AFRICAN DESTINATIONS NEW OFFICE INTERIORS

RENDER DOCUMENT

Rev 1
28 10 2024

BY ACO.\RCH

GROUND FLOOR RECEPTION

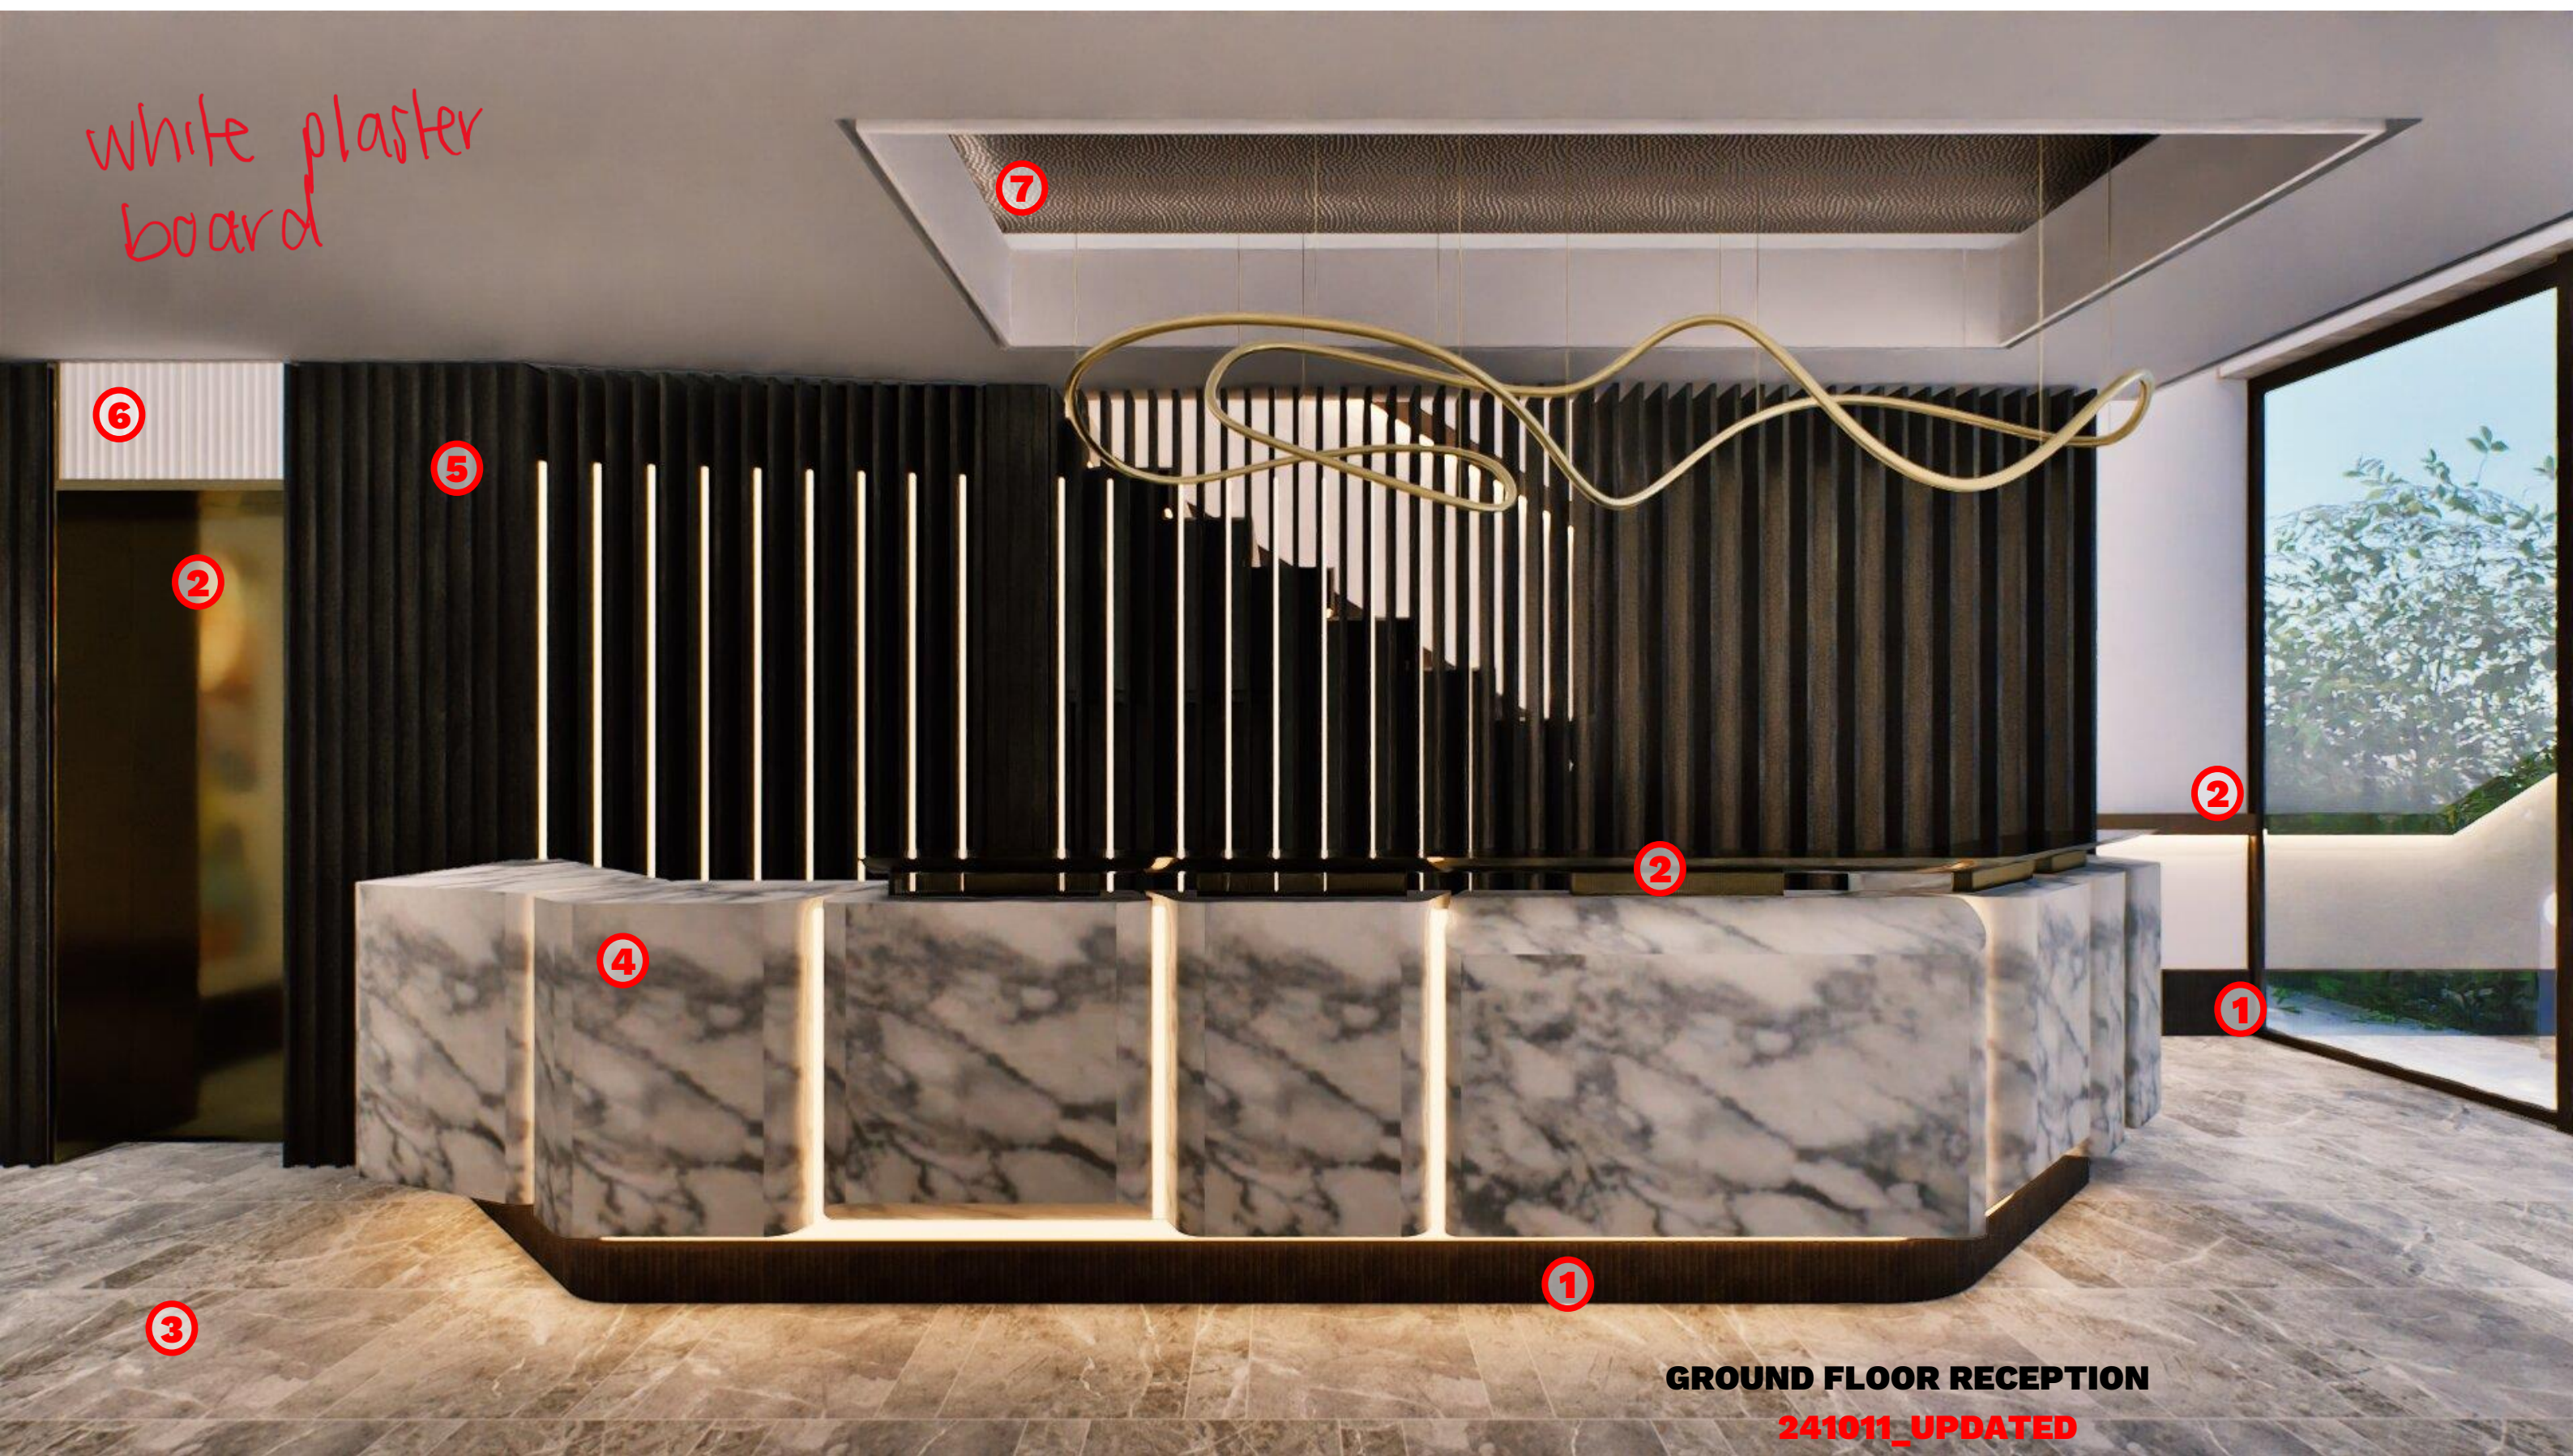
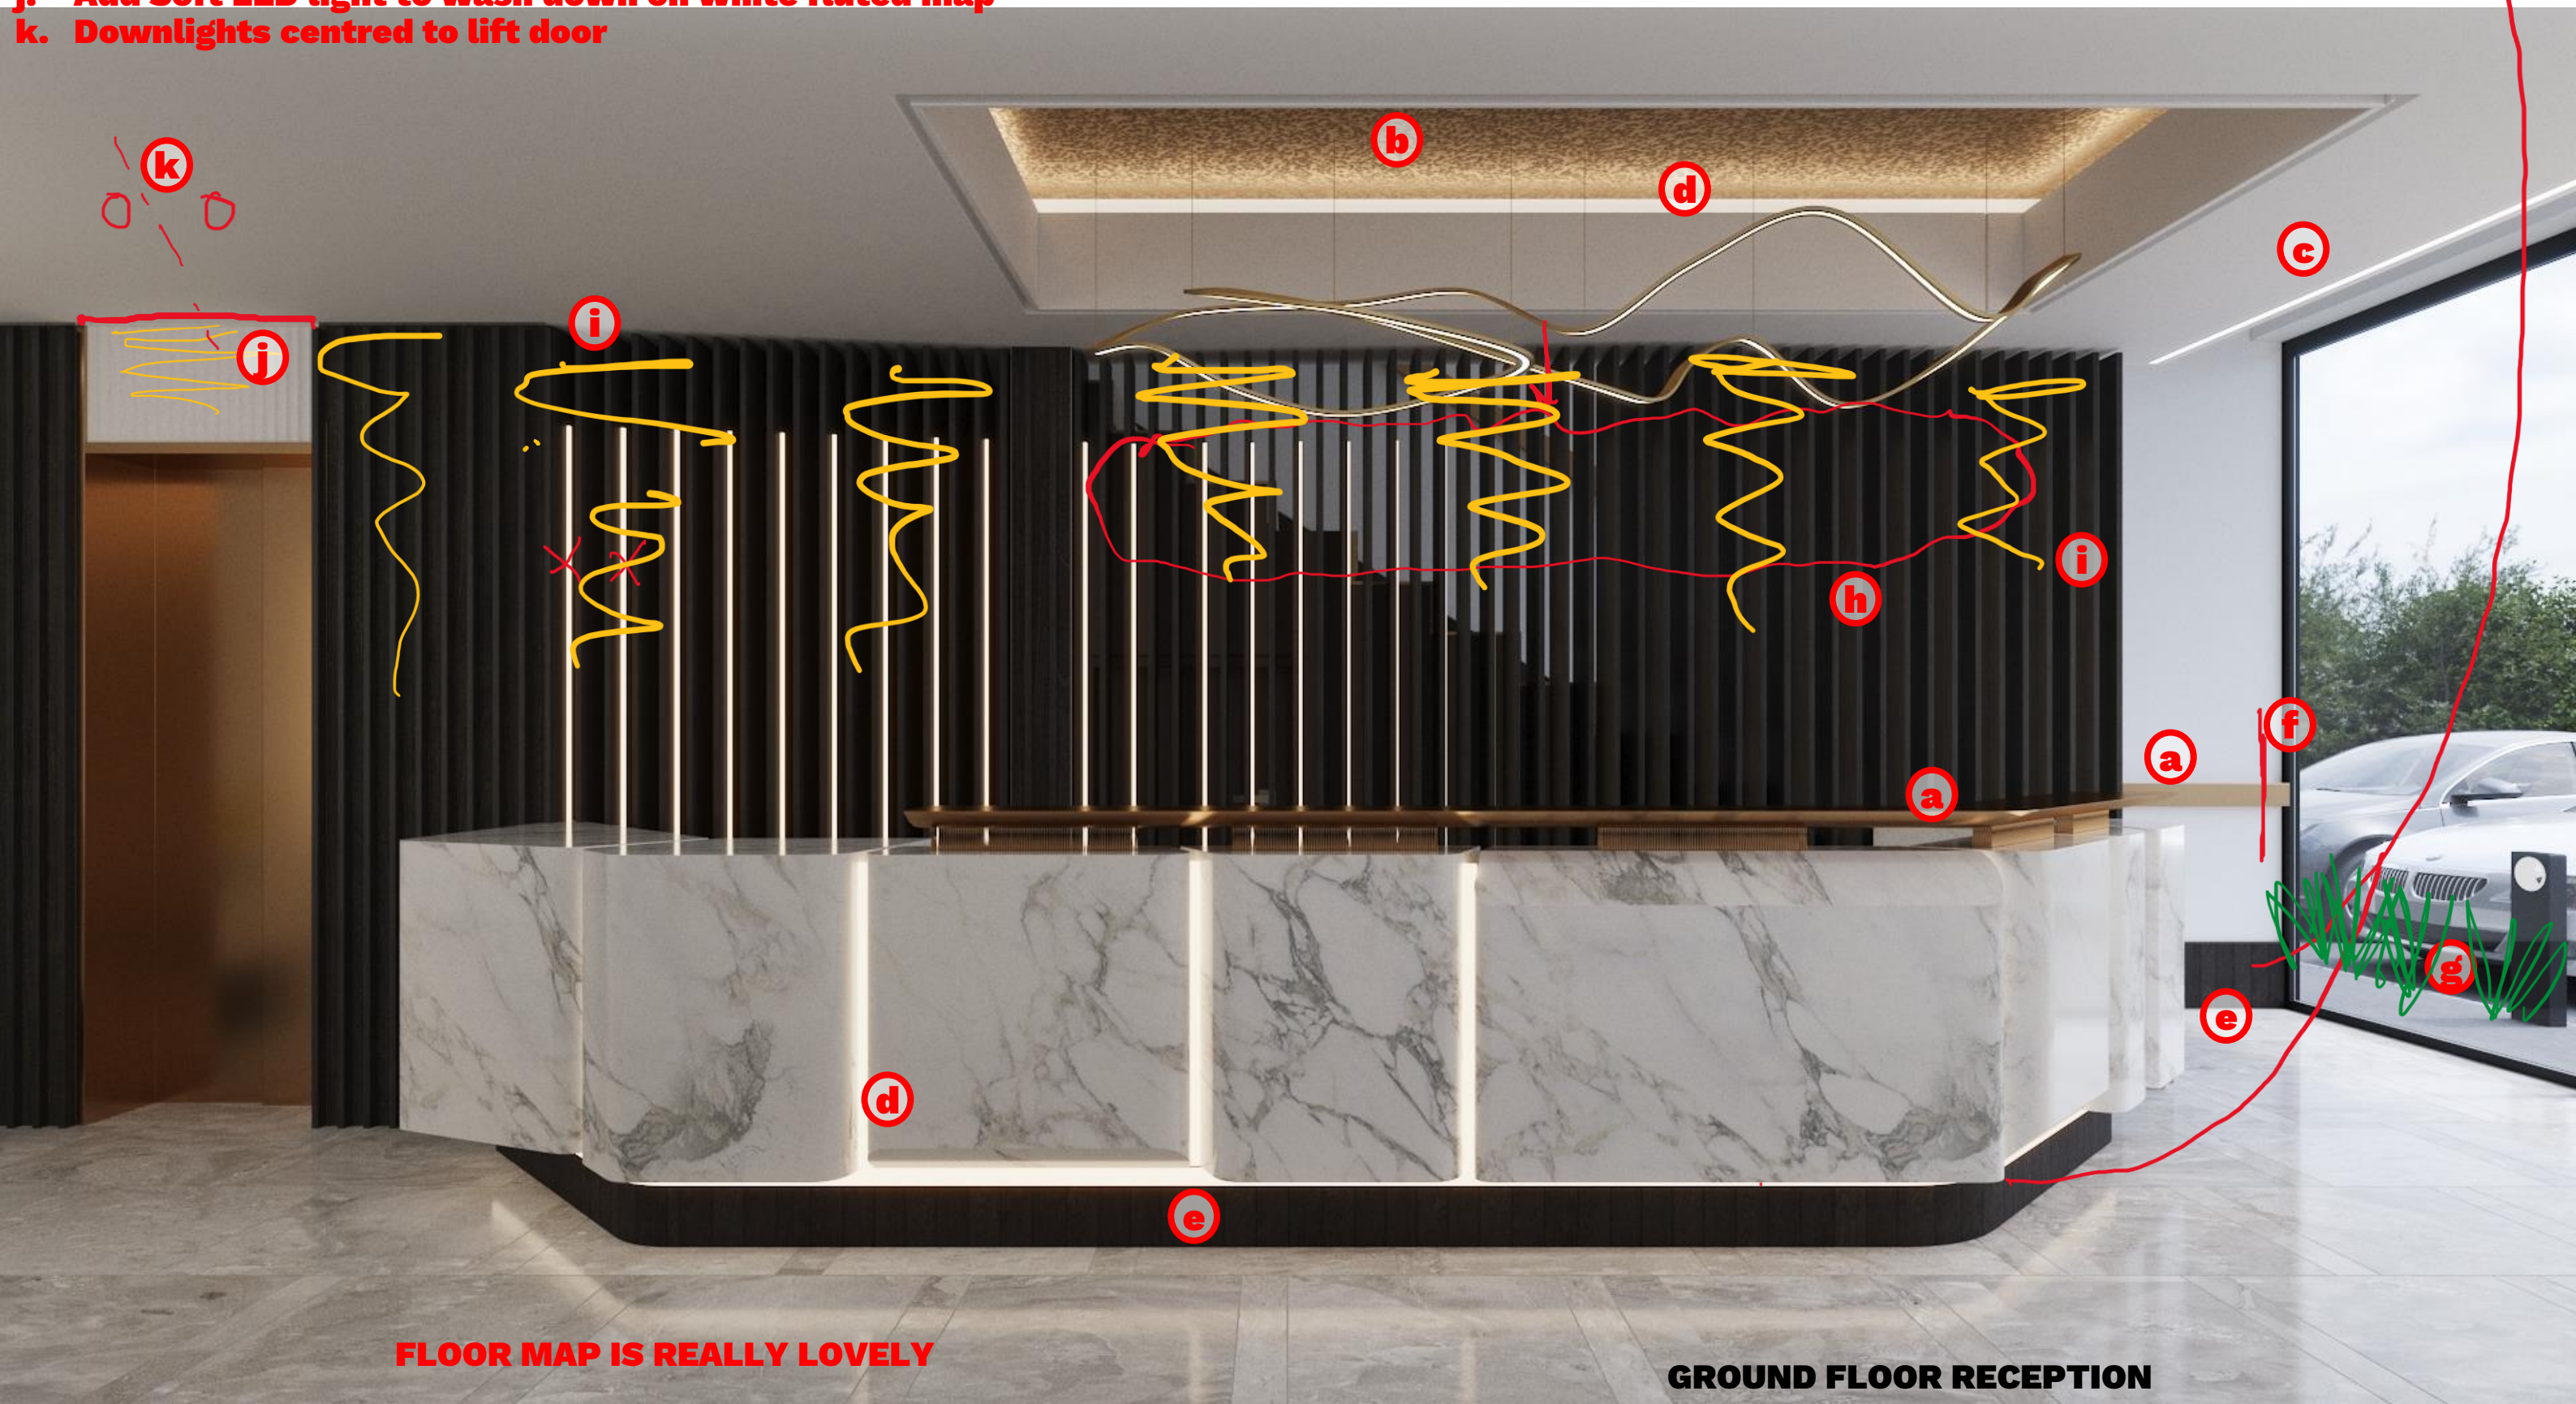
- a. Material to be less gold and more bronze
- b. Bush hammer texture not quite right, map seems dirty and too gold
- c. No LED in this recess
- d. All LEDs to have less of a harsh straight line to them, softer emitting glow – MUSTNT SEE LIGHT SOURCE
- e. Timber fluted skirting is very dark- Texture and map incorrect – see 01 on previous slide
- f. Cut back railing 100mm if possible
- g. Add some planters
- h. Drop feature chandelier as shown
- i. Remove LED Strips in screen, wash light down as shown by yellow scribbles
- j. Add Soft LED light to wash down on white fluted map
- k. Downlights centred to lift door

- a. Scale map by down 50% - needs to be smaller. Also a touch too light now.
 - b. Add a soft timber oak map to the wall behind stair.
 - c. Can we add a person? Preferably a Muslim lady (no full burkha though)
 - d. This element behind screen looks too prominent- perhaps we can hide with maps better
 - e. Timber screen texture has gone a bit grey and dull? Preferred the previous draft
 - f. Perhaps we need some lights washing down between some the slats as well? But not as pronounced as previous draft.
- Screen needs to feel evenly lit up.

g. Downlights need to be centered to lift door and 200mm apart from each other- ie closer together

h. Ceiling Recess - Glow was better in previous draft. Hide the strip light source.

i. Gentle LED strip glow underneath brass counter

241030 RENDER DRAFT 02

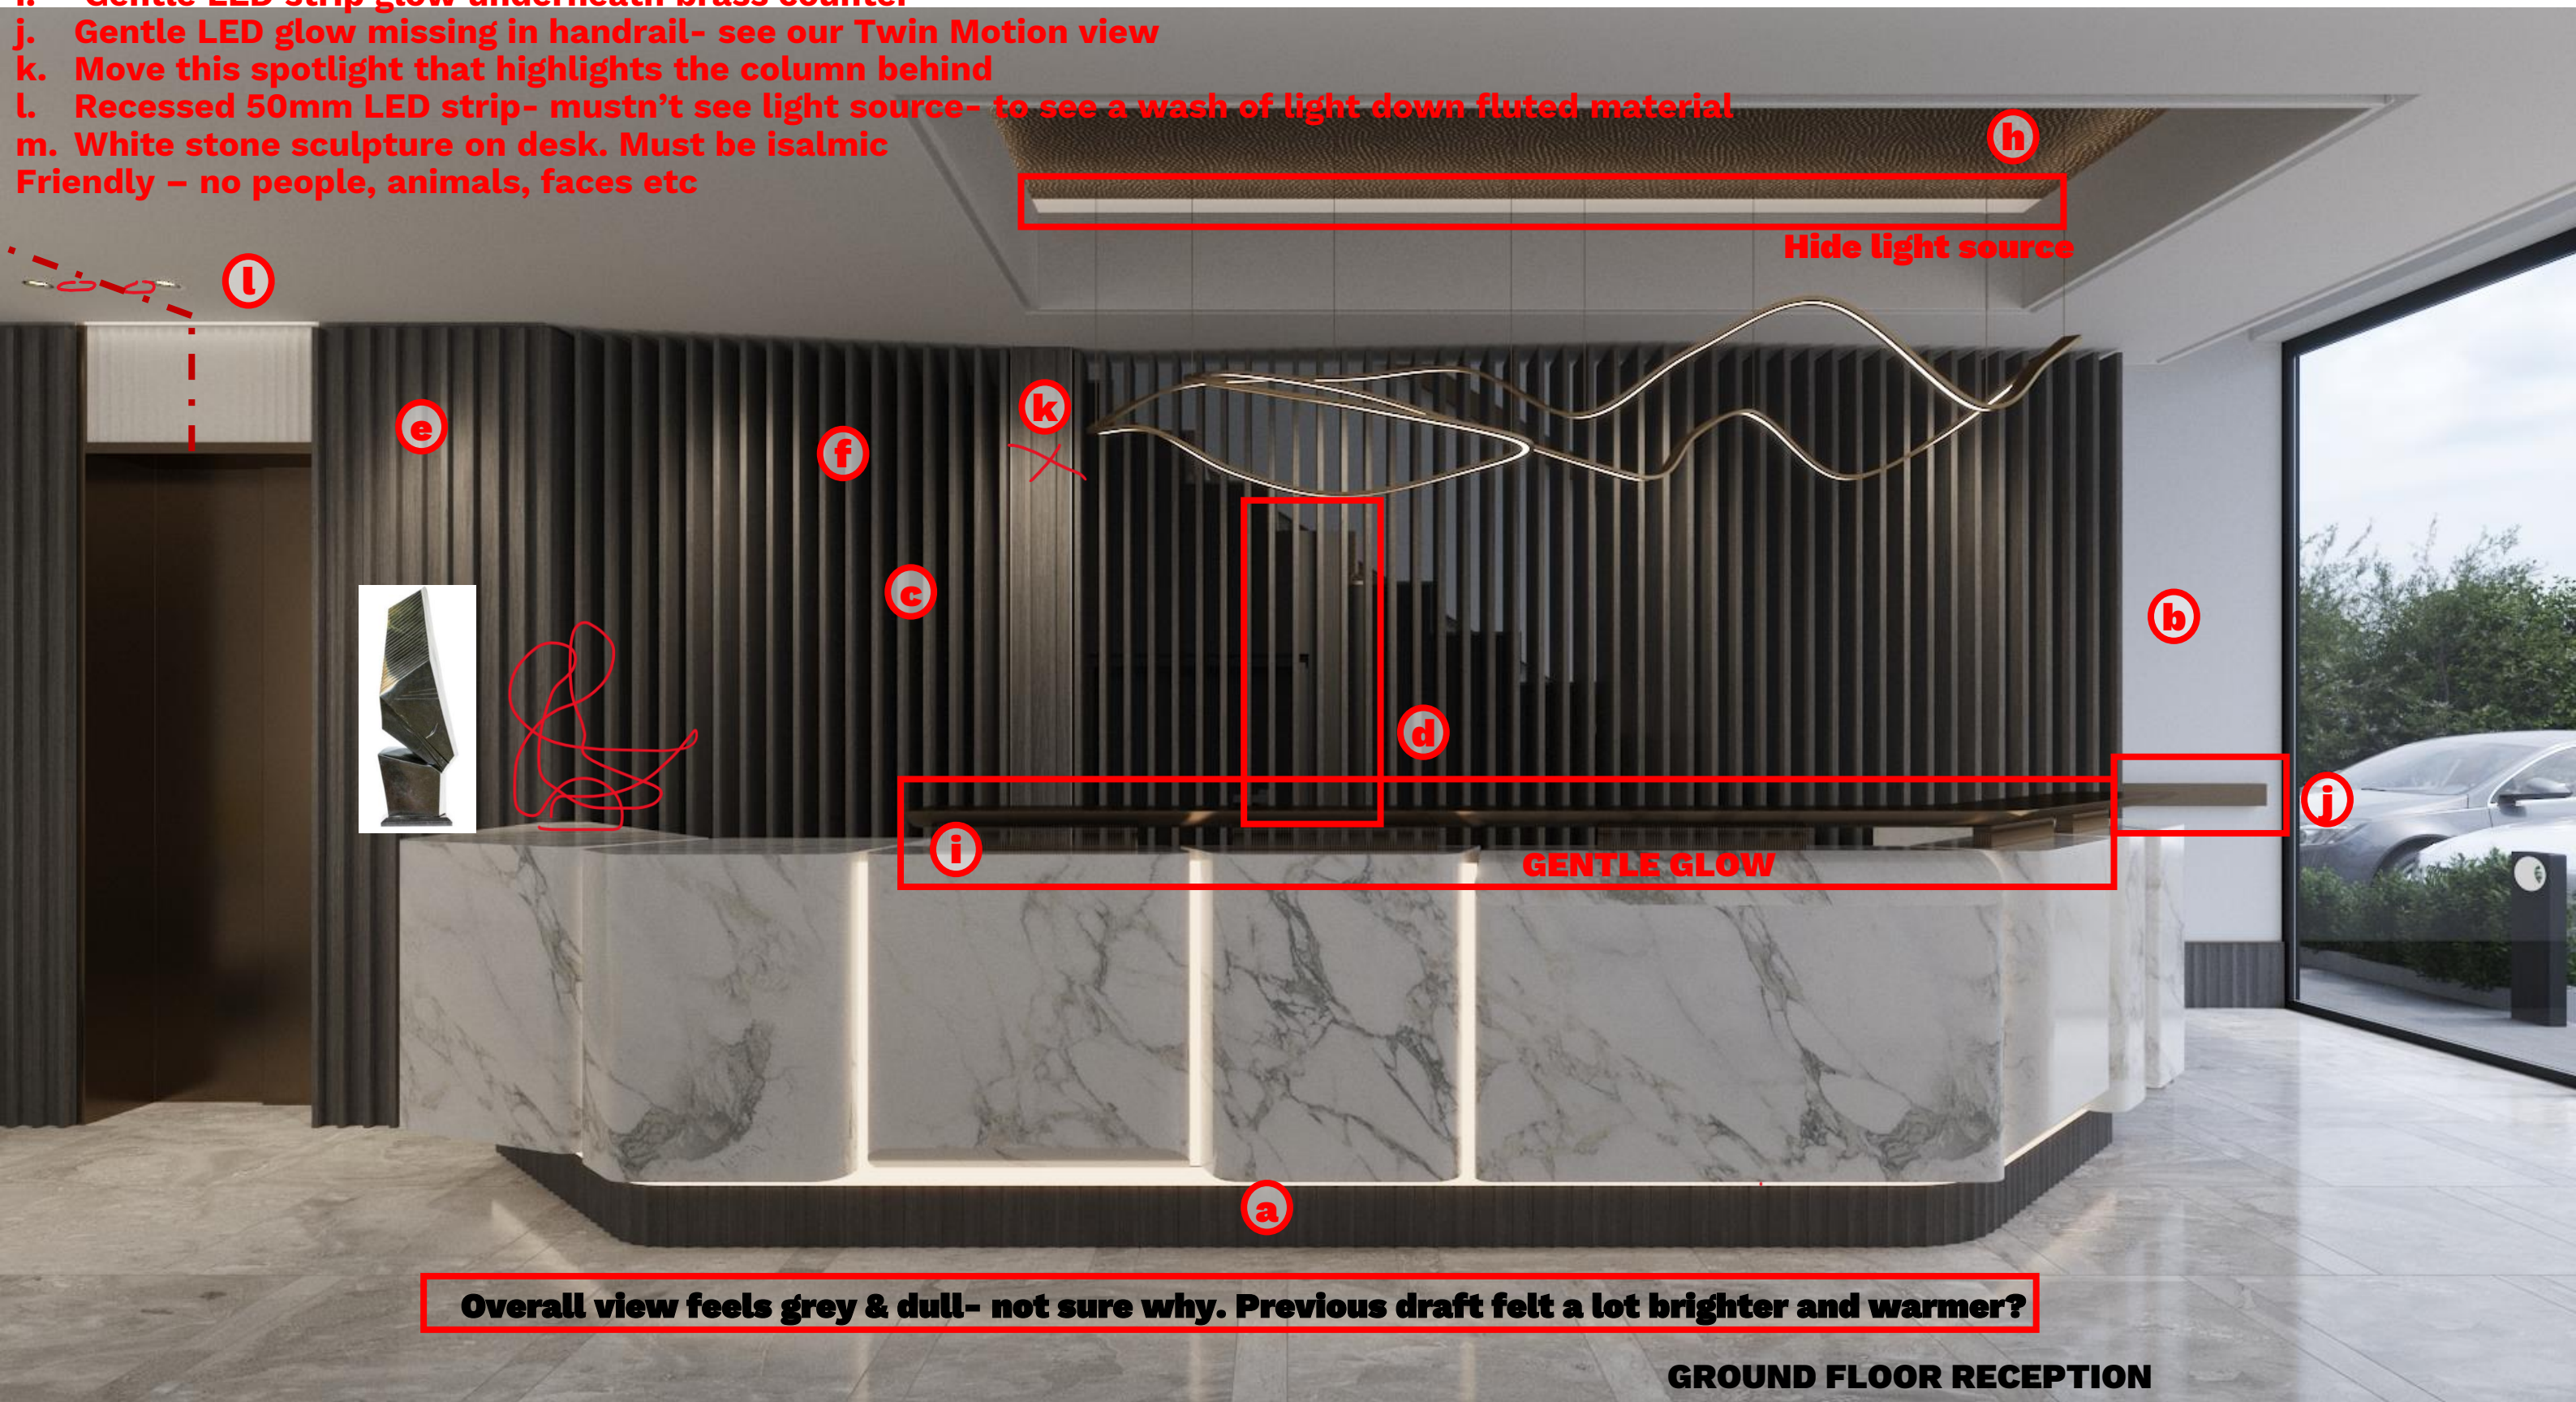
j. Gentle LED glow missing in handrail- see our Twin Motion view

k. Move this spotlight that highlights the column behind

l. Recessed 50mm LED strip- mustn't see light source- to see a wash of light down fluted material

m. White stone sculpture on desk. Must be islamic

Friendly - no people, animals, faces etc

Overall view feels grey & dull- not sure why. Previous draft felt a lot brighter and warmer?
